Well Name: COTTON DRAW UNIT	Well Location: T25S / R32E / SEC 28 / NWNE / 32.1068888 / -103.6788959	County or Parish/State: LEA / NM
Well Number: 51	Type of Well: OIL WELL	Allottee or Tribe Name:
Lease Number: NMLC062300	Unit or CA Name: COTTON DRAW DELAWARE	Unit or CA Number: NMNM70928A
US Well Number: 300250823200S1	Operator: CHEVRON USA INCORPORATED

Sundry ID: 2833572

Type of Action: Plug and Abandonment

**BUREAU OF LAND MANAGEMENT  
Carlsbad Field Office  
620 East Greene Street  
Carlsbad, New Mexico 88220  
575-234-5972**

**CURRENT  
WELLBORE DIAGRAM**

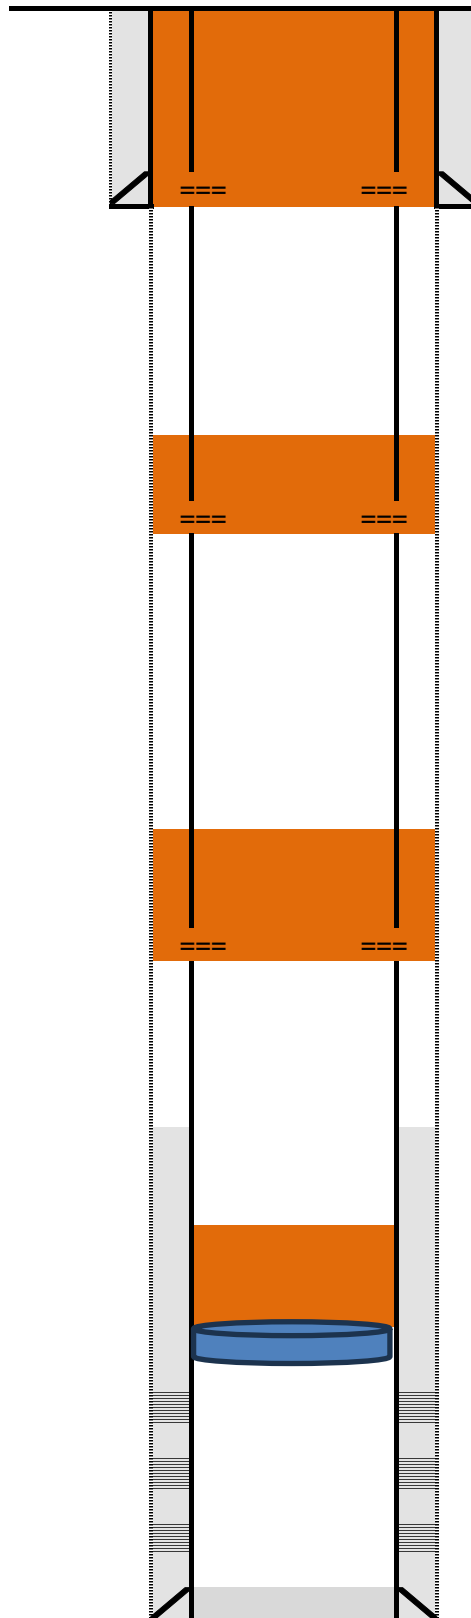
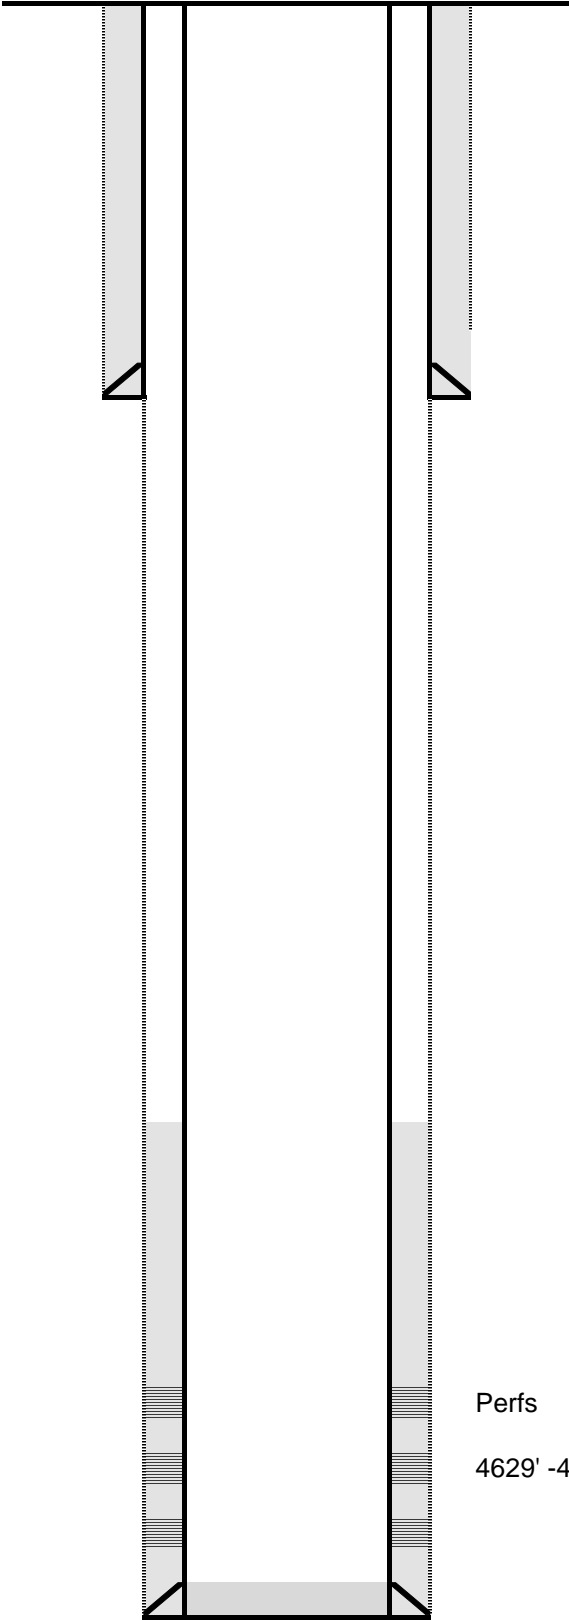
**REVISED**

Perf/Sqz 53sx Class C f/ 3,000' - 2,700'  
WOC/tag plug (In 21 sxs/Out 32 sxs)

Spot 35sx Class C f/ 4,600' - 4,100'  
WOC/tag plug  
CIBP @ 4579'

1. MIRU P&A Rig.
2. Current WBD shows no pipe in well. ND WH and NUBOP.
3. RIH w/ CIBP set at 4579'. Load well test casing to 500# and perform CBL. Return to Engineer/NMOCD.
4. RIH w/ tubing and prep to P&A.
5. Spot 35sx Class C Cement from 4,600'-4,100'. WOC/Tag. Get approval to waive tag if step 4 passed. (Perforations Plug)
6. Perf/Sqz 53sx Class C from 3,000'-2,700'. WOC/Tag and Pressure Test (Castille Plug)
7. Perf/Sqz 48sx Class from 1,200'-1,000'. WOC/Tag and Pressure Test (Salado Plug)
  - a. Bubble test well. If all passes proceed to next step, if fail contact engineer to cut and pull casing.
8. Perf/Circulate 100sx Class from 400'-3'. Visually confirm cement at surface. (Surface Plug)
9. RD and hand over well to for cut/off and restore.

Sundry ID		2833572					
Plug Type	Top	Bottom	Length	Tag	Sacks	Cement Class	Notes
Surface Plug	0.00	100.00	100.00	Tag/Verify			
7.625 inch- Shoe Plug	310.36	414.00	103.64	Tag/Verify	79.00	C	Perf and squeeze from 414' to surface. (In 29 sxs/Out 50 sxs) Verify at surface.
Top of Salt @ 1140	1078.60	1190.00	111.40	Tag/Verify	25.00	C	Perf and squeeze from 1200' to 1078'. WOC and Tag. (In 9 sxs/Out 16 sxs)
Spacer Plug @ 2950	2870.50	3000.00	129.50	If solid base no need to Tag (CIBP present and/or Mechanical Integrity Test), If Perf & Sqz then Tag, Leak Test all CIBP if no Open Perforations	53.00	C	Perf and squeeze from 3000' to 2700'. (In 21 sxs/Out 32 sxs) WOC and Tag.
Base of Salt @ 4357	4263.43	4407.00	143.57	Tag/Verify			
Delaware @ 4600	4504.00	4650.00	146.00	If solid			
CIBP Plug	4544.00	4579.00	35.00	If solid base no need to Tag (CIBP present and/or Mechanical Integrity Test), If Perf & Sqz then Tag, Leak Test all CIBP if no Open Perforations	25.00	C	Set CIBP at 4579'. Spot cement from 4579' to 4263'.
